LEARNING RESOURCES CENTER
BUILDING 'D' AND 'CR' REMODEL

VENTURA COLLEGE

September 24, 2001
KBZ Job No. 93-18

INSPECTOR COPY

1 Second Floor Plan Building "CR" Remodel
 SCALE: 1/8" = 1'-0"

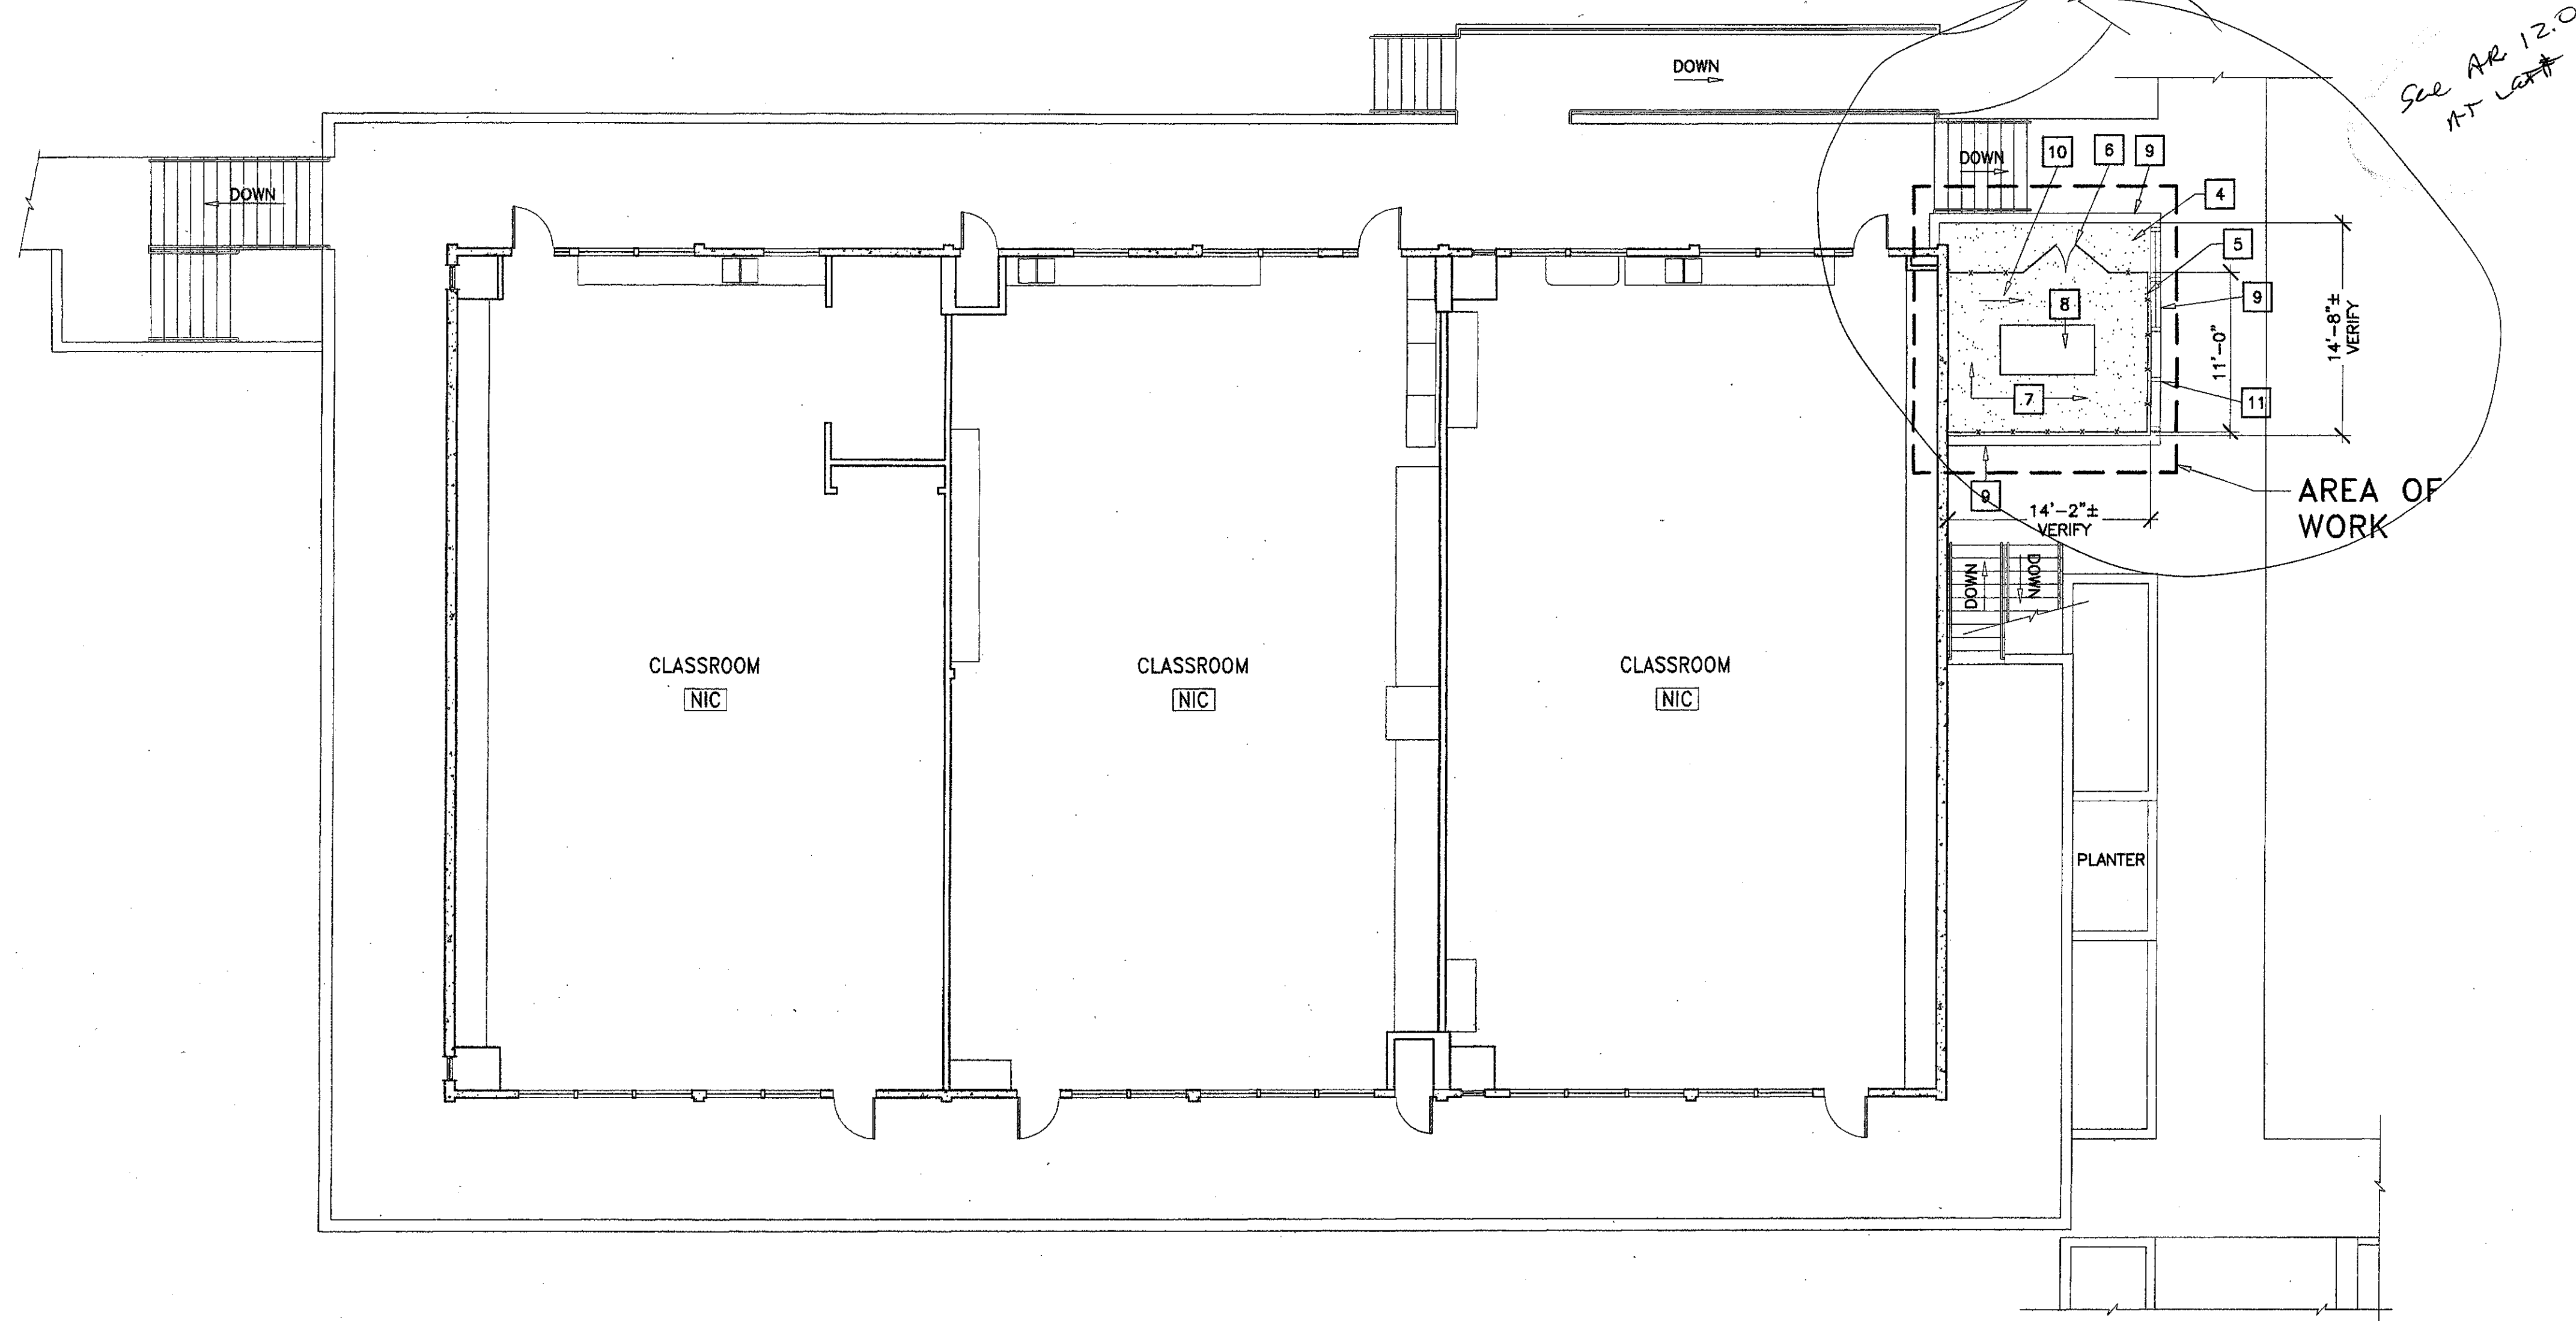
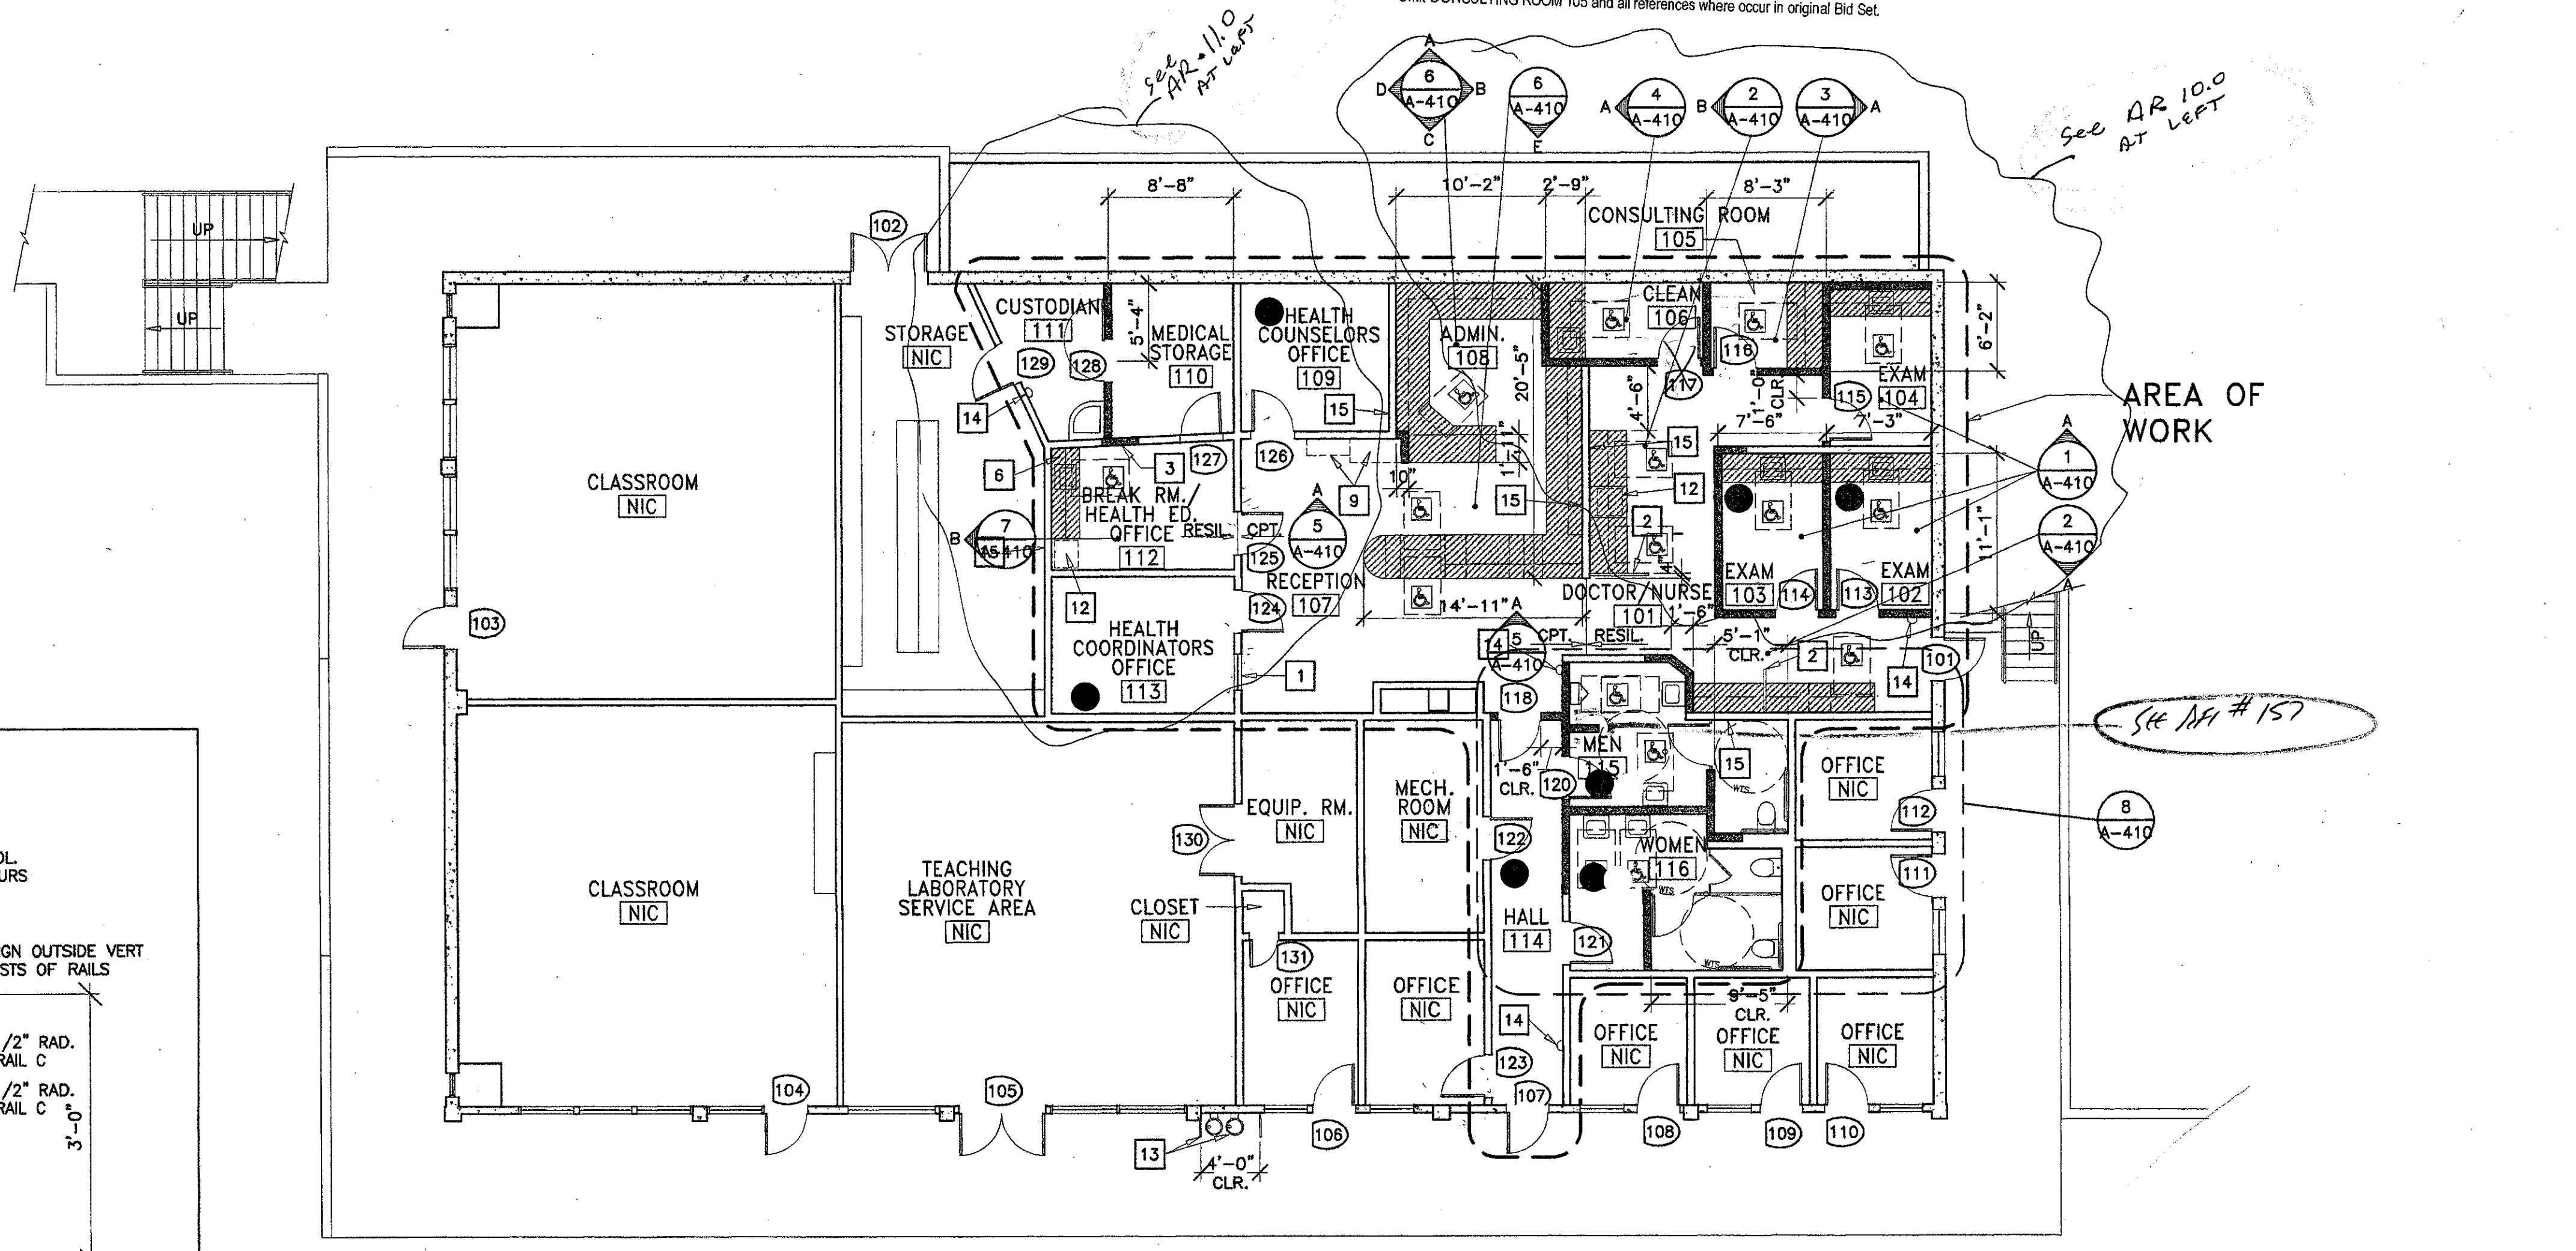
APPENDUM 7
 Item No. 4 Drawing Sheet A-112 Partial Second Floor Plan - Building "CR"
 Refer to architectural revision drawing AR120 which clarifies construction of fence enclosure at new mechanical equipment.

ITEM 21 Drawing Sheet A-112 APPENDUM 2
 Keynote 15 applies to all existing stud walls to remain which are to receive cabinets.

Item No. 8 Drawing Sheet A-112 APPENDUM 3
 At existing stud partitions in the following locations, remove existing wall finishes on one (1) side of wall and install new sound attenuation batt insulation from floor to underside of roof or floor structure per specifications section 07210 and replace wall finishes to match existing finishes removed:
 1. Building "CR" - Health Counselor's Office 109
 2. Building "CR" - Health Coordinator's Office 113

Item No. 1 Drawing Sheet A-112 - Building "CR" APPENDUM 7
 Only CONSULTING ROOM 105 and all references where occur in original Bid Set.

1 Building 'CR' First Floor Reflected Ceiling Plan
 SCALE: 1/8" = 1'-0"

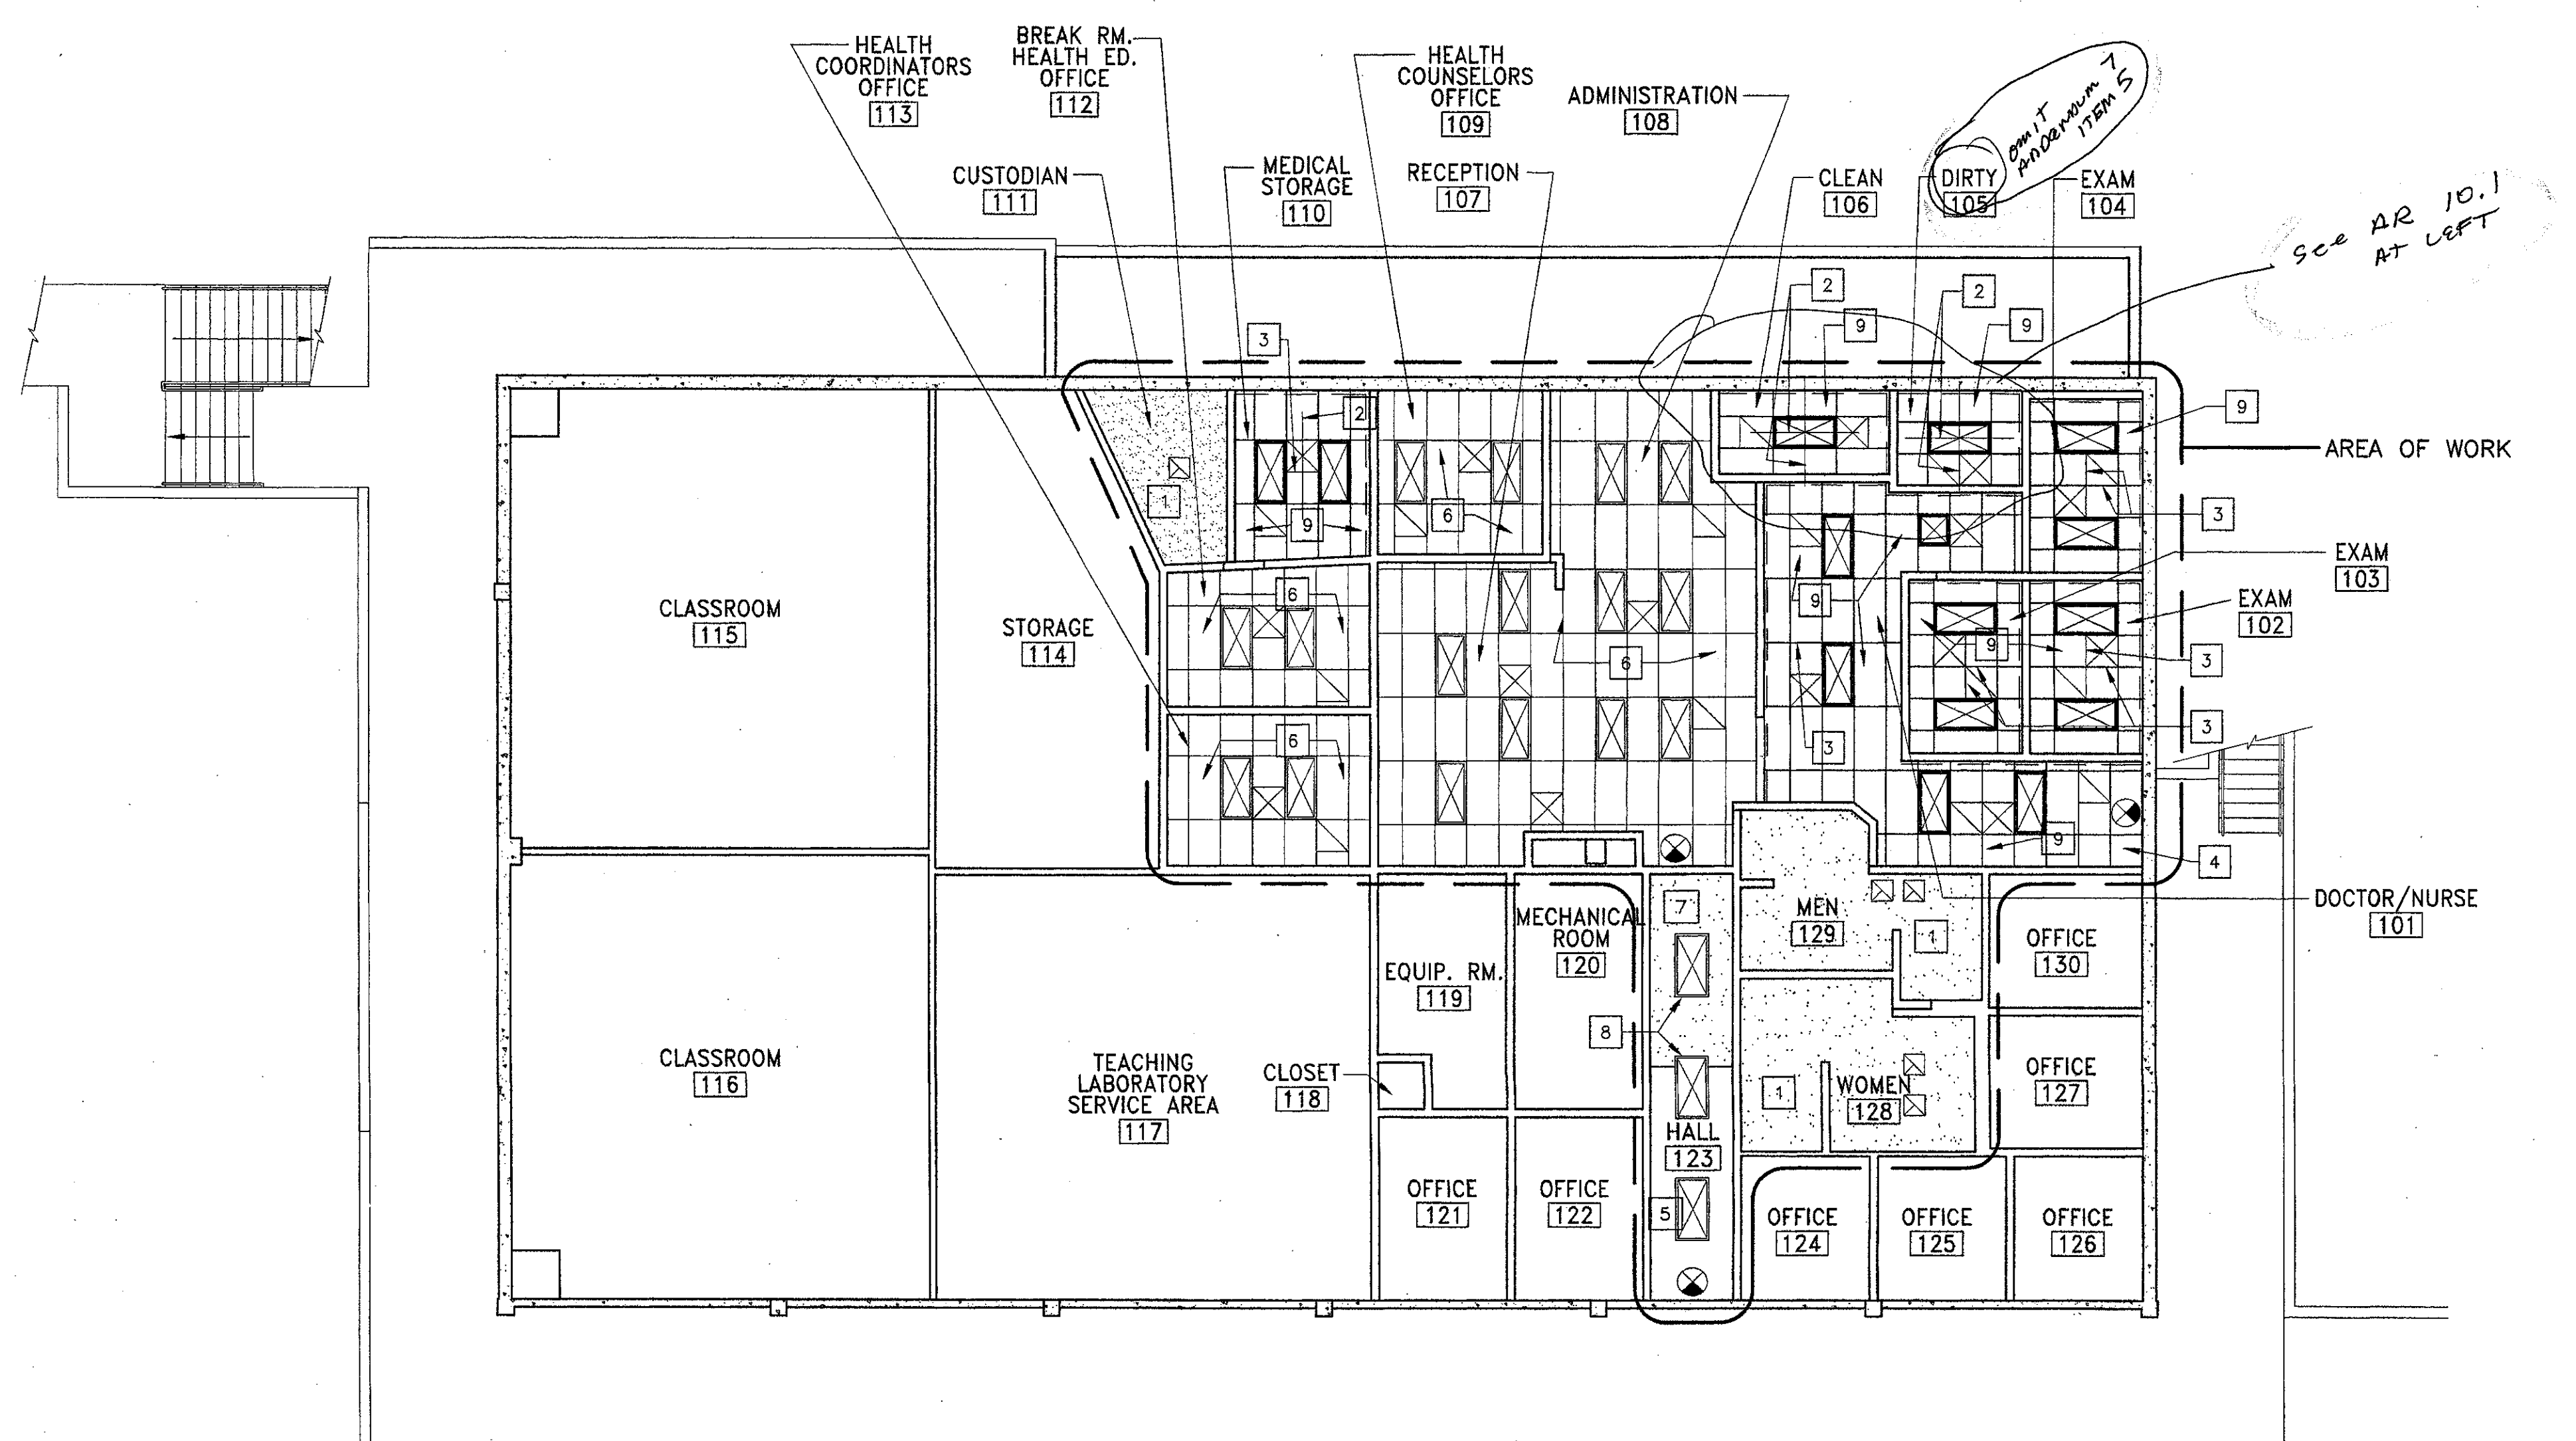
ITEM 14. Drawing Sheet A-122 ADDENDUM 2
 Refer to Building 'CR' first floor reflected ceiling plan. Light fixtures not shown at men's and women's restrooms shall be provided and located per Building 'CR' lighting plan in Electrical Drawing Sheets.

ITEM 15. Drawing Sheet I-112, A-122, A-601, E-201, E-302, E-402, E-501, E-601
 'CR' Building Room Numbers are correct on Sheets A-112 and A-601. Some 'CR' Building Room numbers are incorrect on Sheets A-122, E-201, E-302, E-402, E-501 and E-601 and are superseded by correct Room numbers on Sheets A-112 and A-601.
